# UNITED STATES PATENT AND TRADEMARK OFFICE

APPLICATION NO.	FILING DATE	FIRST NAMED INVENTOR	ATTORNEY DOCKET NO.	CONFIRMATION NO.
10/527,251	03/09/2005	Jean Taylor	31132.339	2831

# Office Action Summary

### **DETAILED ACTION**

Figure 1

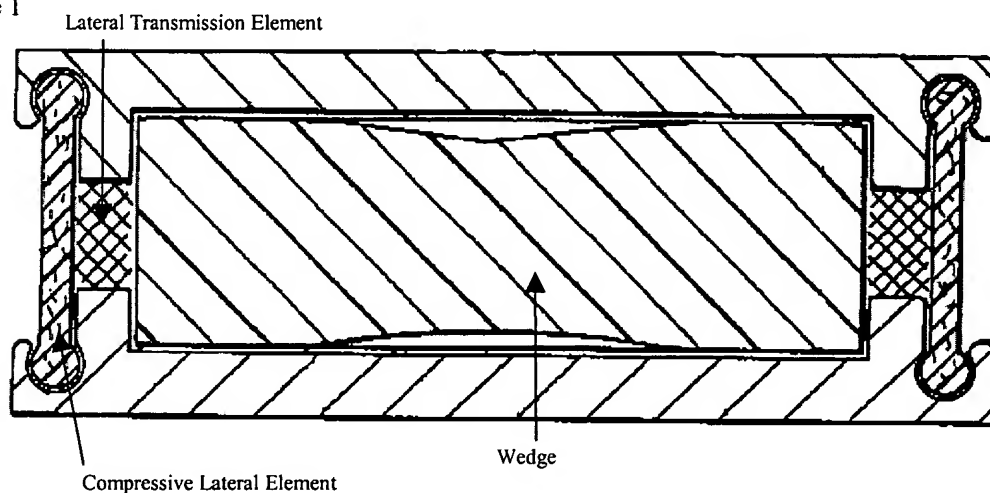
Regarding claim 14, Eberlein discloses a device that is placed in an intervertebral disc space that is located between the spinous processes of two vertebrae comprising an elastically deformable wedge wherein the deformable zone is the entire wedge, two compressive lateral elements, and two lateral transmission elements (see Figure 1 below). The compressive lateral elements are disposed on either side of the wedge in a longitudinal direction and are capable of being deformed

between releasing and compressive positions. The lateral transmission elements are disposed between the wedge and the compressive lateral elements and are capable of pressing against the wedge in the transverse direction. Regarding claim 15, Eberlein discloses a device wherein the wedge has a limit of compressibility in the transverse direction and is capable of reaching that limit at a predetermined tilted position.

Regarding claim 16, Eberlein discloses a device wherein the compressive lateral elements have a limit of deformation in the transverse direction and is capable of reaching that limit at a predetermined tilted position. Regarding claim 17, Eberlein discloses a device wherein the compressive lateral elements are elastically deformable between the releasing and compressive positions. Regarding claim 18, Eberlein discloses a device wherein the compressive lateral elements are elastically deformable along an axis of the spine.

Figure 2

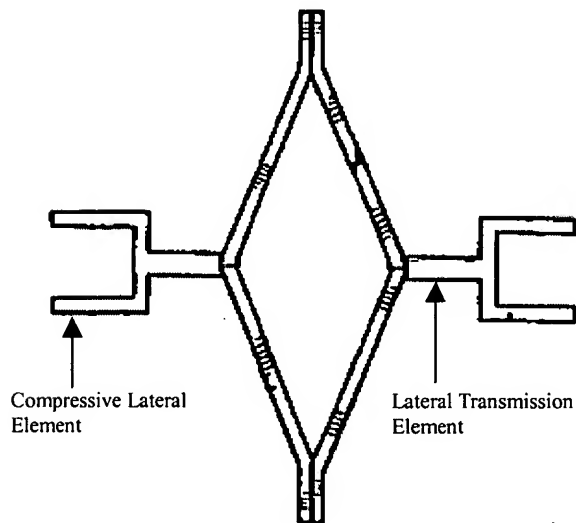
Regarding claim 14, Elberg discloses a device comprising two compressive lateral elements and two lateral transmission elements (see Figure 2 below). The compressive lateral elements are disposed on either side of the wedge in a longitudinal direction wherein the compressive lateral elements are deformable between releasing positions and compressive positions. The two lateral transmission elements disposed between the compressive lateral elements and the wedge and are capable of pressing against the wedge in the transverse direction. Regarding claims 17 and 18, Elberg discloses a device wherein the compressive lateral elements are elastically deformable between the releasing and compressive position and wherein the compressive lateral elements are elastically deformable generally along an axis of the spine (column 4 lines 52-53). Regarding claim 19, Elberg discloses a device wherein the compressive lateral elements are independent of one another and wherein each element is capable of being connected to a vertebra with one end and to another vertebra at the other end.

anchorage screws (column 4 lines 56-57). Regarding claim 21, Elberg discloses a device wherein the compressive lateral elements are capable of passing beneath the laminae of the vertebra. Regarding claim 22, Elberg discloses a device wherein the compressing lateral elements are capable of connecting to an interpedicular transverse connecting bar that is placed in the underlying vertebrae. Regarding claim 24, Elberg discloses a device wherein the lateral transmission elements are small bars. Elberg fails to disclose the device further comprising an elastically deformable interspinous wedge inserted into the body of the device capable of being inserted between the spinous processes of two vertebrae. Samani teaches a device comprising an elastically deformable wedge capable of being placed in the body of a device that is capable of being inserted between the spinous processes of two vertebrae in order to ensure a supplementary cushioning of the vertebrae (column 4 lines 44-51). It would have been obvious to one having ordinary skill in the art at the time the invention was made to manufacture the device of Elberg with an elastically deformable wedge inserted into the body of the device in view of Samani in order to ensure a supplementary cushioning of the vertebrae.

Regarding claim 26, the combination of Elberg and Samani disclose a device wherein the compressive lateral elements are capable of being deformable between releasing positions wherein they are relatively spaced apart from the wedge and compressive positions wherein they are relatively close to the wedge in a transverse direction. Regarding claim 27, the combination of Elberg and Samani disclose a device wherein the two lateral transmission elements are capable of being disposed in a

manner to press against the wedge in the transverse direction when the compressive lateral elements are displaced in the compressive position.

Figure 3

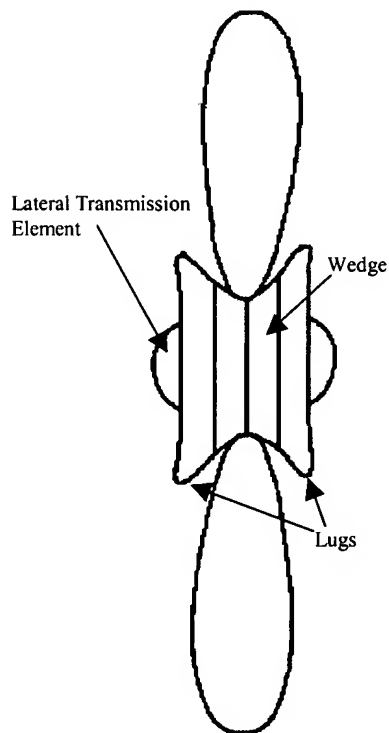
Regarding claim 28, Zucherman discloses a device comprising an elastically deformable interspinous wedge, wherein the zone of deformation is the entire wedge, capable of being inserted between the spinous processes of two vertebrae and first and second lateral transmission elements (see Figure 3 below). Regarding claim 30, Zucherman discloses a device wherein the first and second lateral transmission elements are bosses. Regarding claim 31, Zucherman discloses a device wherein the bosses are integral with the wedge. Regarding claim 32, Zucherman discloses a device wherein the wedge includes recesses capable of receiving the bosses. Regarding claim 33, Zucherman discloses a device wherein the wedge comprises two curved recesses

bound by two lugs capable of broadly enveloping the spinous processes. Zucherman fails to disclose the device further comprising a circular strap capable of being placed around at least two spinous processes and the wedge. Howland teaches a device comprising a strap capable of being placed around at least two spinous processes and a wedge in order to hold the device in place (column 4 lines 58-67). It would have been obvious to one having ordinary skill in the art at the time the invention was made to manufacture the device of Zucherman further comprising a strap capable of being placed around at least two spinous processes and a wedge in view of Howland in order to hold the device in place.
